**From:** Ken Spencer <Kenneth.Spencer@pgn.com>  
**Sent:** Monday, August 2, 2021 9:24 AM  
**To:** Aaron Panko  
**Cc:** Luke Gmazel  
**Subject:** RE: Notice of Filing / Request for Comments - Case No. SPR-ADJ21-20 for 1500 Block of 23rd St SE  
**Attachments:** Comments for PW re trans location.pdf

**From:** Shelby Guizar <SGuizar@cityofsalem.net>  
**Sent:** Thursday, July 29, 2021 9:34 AM  
**To:** Shelby Guizar <SGuizar@cityofsalem.net>  
**Cc:** Aaron Panko <APanko@cityofsalem.net>  
**Subject:** Notice of Filing / Request for Comments - Case No. SPR-ADJ21-20 for 1500 Block of 23rd St SE

*Application Summary:* Proposed development of a new 50,000 square foot office building for the City of Salem Shops Complex.

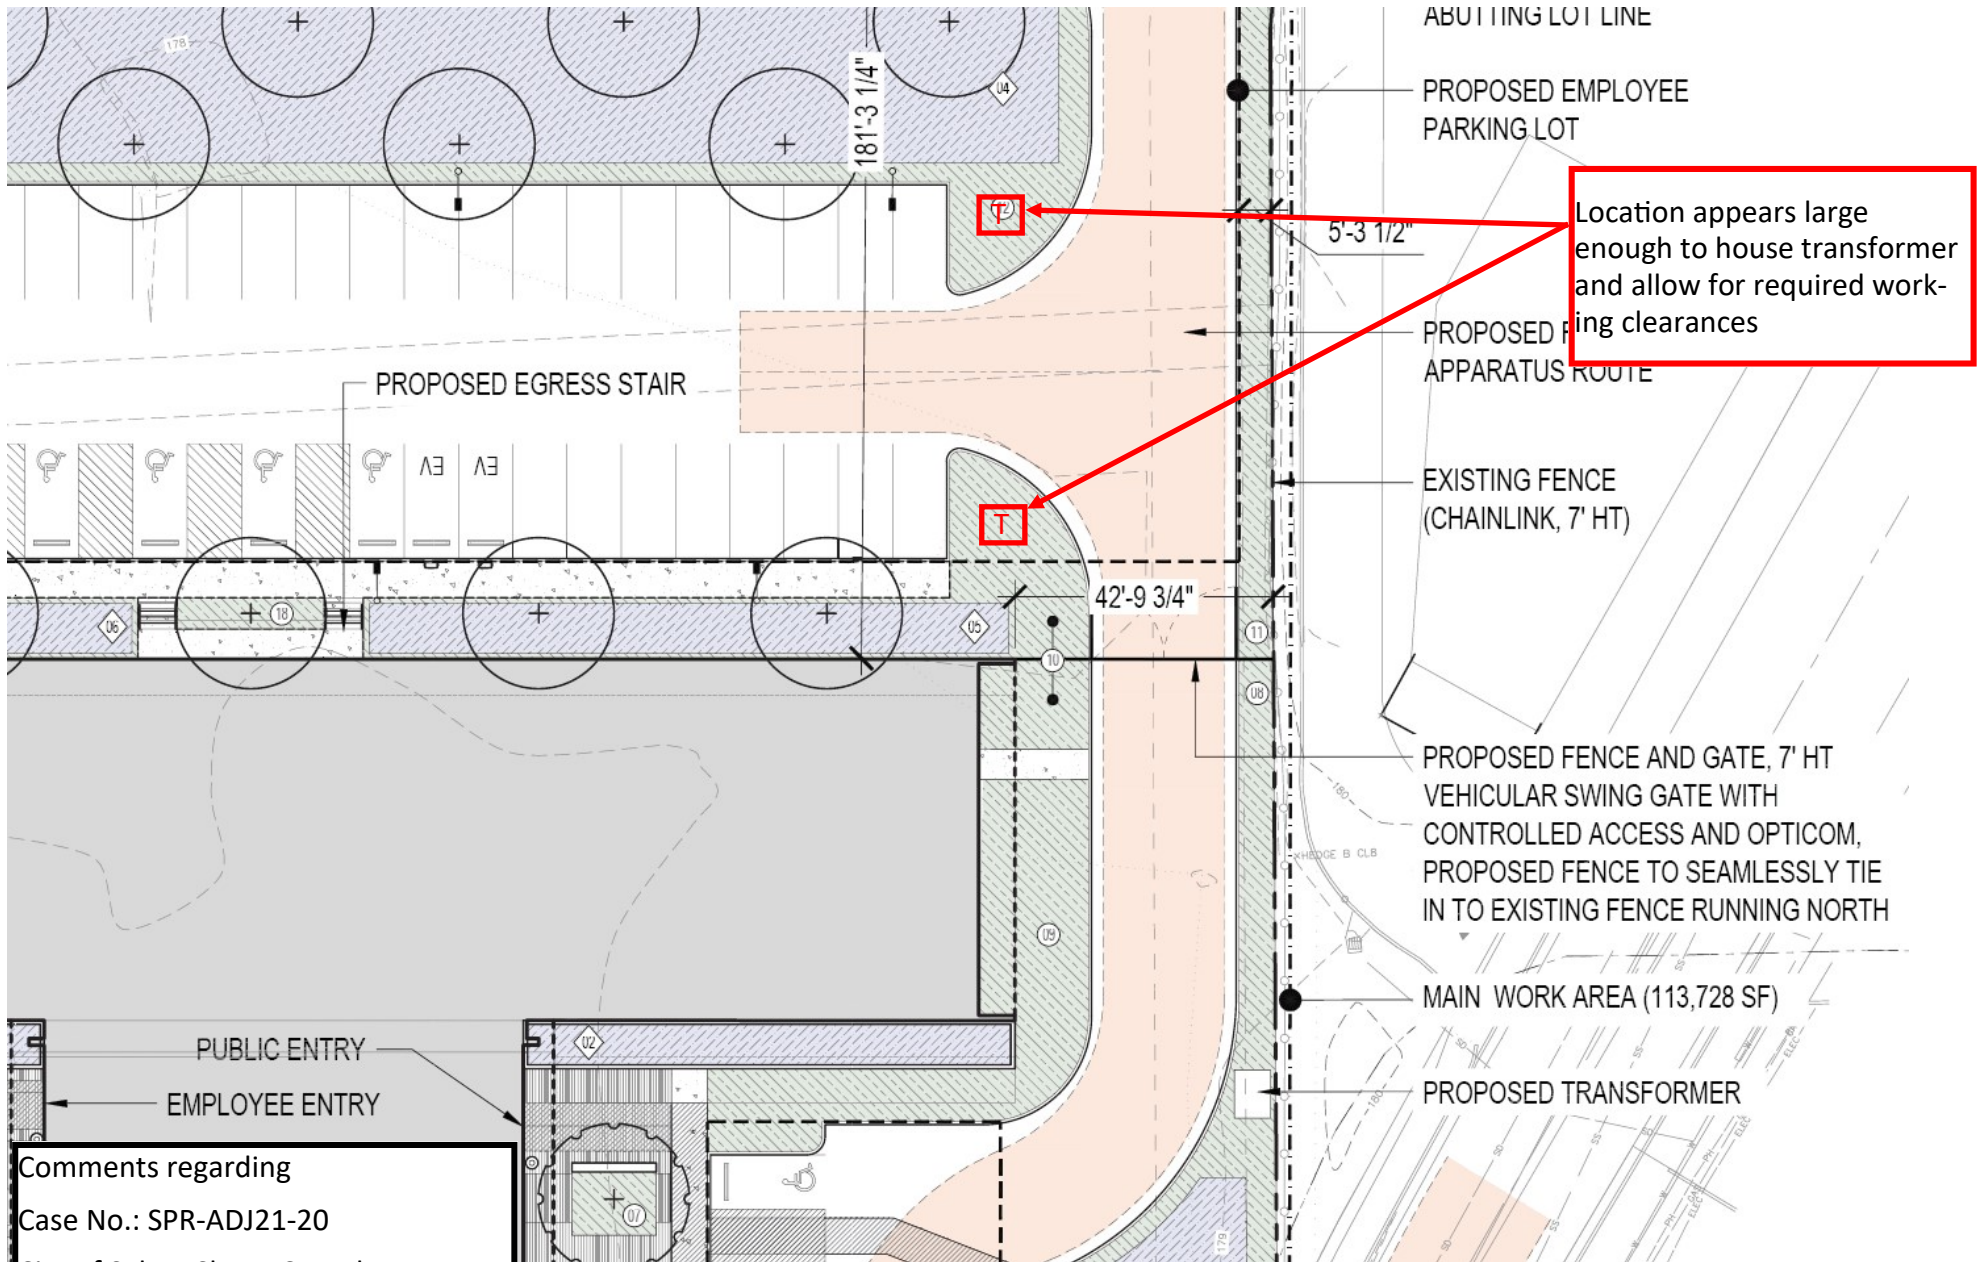
The planned location for the building transformer is likely not large enough for the required working clearance around the equipment/vault. Attached is a page showing the dimensions for the pad/vault on which the transformer will sit (as well as clearance requirements). The vault is 68"x134". The allocated space appears to be slightly deeper than 63-1/2". This dimension precludes the necessary 36" clearance behind the transformer (clear space to existing fence).

For your consideration I've included a partial site plan on which I've noted two possible locations for the transformer. The locations appear to be large enough for both the equipment and clearances.
